**Trans Mountain Pipeline ULC (Trans Mountain)
Trans Mountain Expansion Project – Condition Compliance**

**Condition 27 – Burnaby Tunnel
File: OF-Fac-Oil-T260-2013-03 61**

**Information Request 15
Due Date: June 6, 2023**

DRAWING TITLE:
TRANS MOUNTAIN EXPANSION PROJECT
BURNABY TUNNEL
BACKFILL POUR SEQUENCE
PROFILE VIEWS

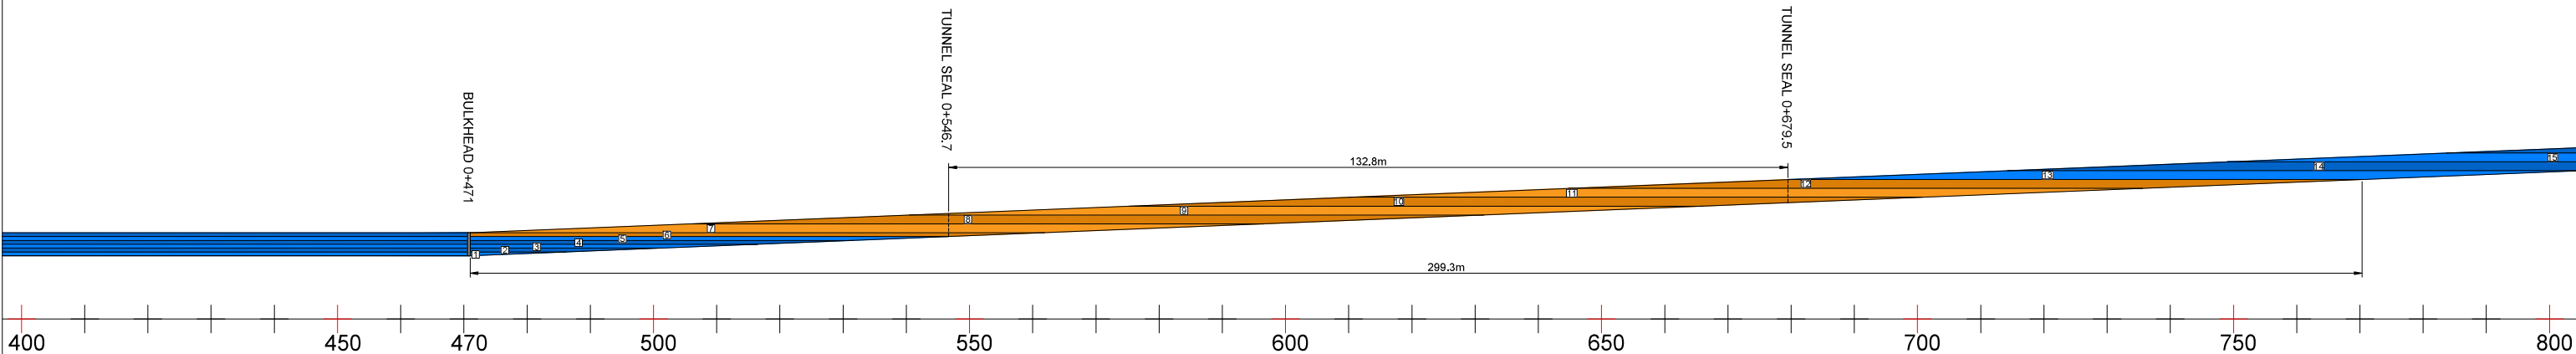
For Action Items 19, in Reference i), the pouring sequence set out in Attachment 3-3, the drawing only illustrates the pouring sequence of portion of the tunnel.

- a. Provide a similar drawing that represents the entire tunnel.
- b. In the drawing in Reference i), two tunnel seals are identified at locations 0+550 and 0+650. Both locations are marked as “min 7m”. Clarify why two seals are identified when the entire length is filled with Type II concrete?
- c. Confirm the tunnel seal length at the location.

- a. Please refer to Attachment 3, which provides a pouring sequence for the entire length of the tunnel. Note that to view the details of pouring sequence, it is necessary to zoom the display to approximately 250% to clearly view the drawing details.

- b. The current execution strategy for backfilling the 4.2% sloped section of the tunnel (extending from 0+471 to 2+611 measured from the Westridge portal) is to place a bulkhead at the bottom of the slope and pour horizontal lifts continuing up the slope. It is proposed to simply switch to the Type II cellular concrete mix prior to the leading edge reaching the start of the tunnel seal and switch back to Type I cellular concrete after the trailing edge passes the end of the tunnel seal. This would allow the full planned tunnel seal area (plus a sizable additional volume) to consist of Type II concrete but reduces person hour requirements (and improves schedule performance) by eliminating the bulkheads on either side. Recall that Type II cellular concrete has a lower hydraulic conductivity than Type I cellular concrete and therefore provides an increased resistance to water penetration. Due to the altered geometry, annular sealing around the 762 mm (NPS 30) pipes will be offset accordingly to maintain a minimum 500 mm setback from the edge of the Type II cellular concrete.

- c. Please refer to the Attachment 3, where the dimensions are provided. The specification of “minimum 7 metres” refers to the length for which the entire diameter of the tunnel is filled with Type II cellular concrete. As discussed in (b), the length over which there will be Type II cellular concrete deployed will be substantially greater than 7 metres.
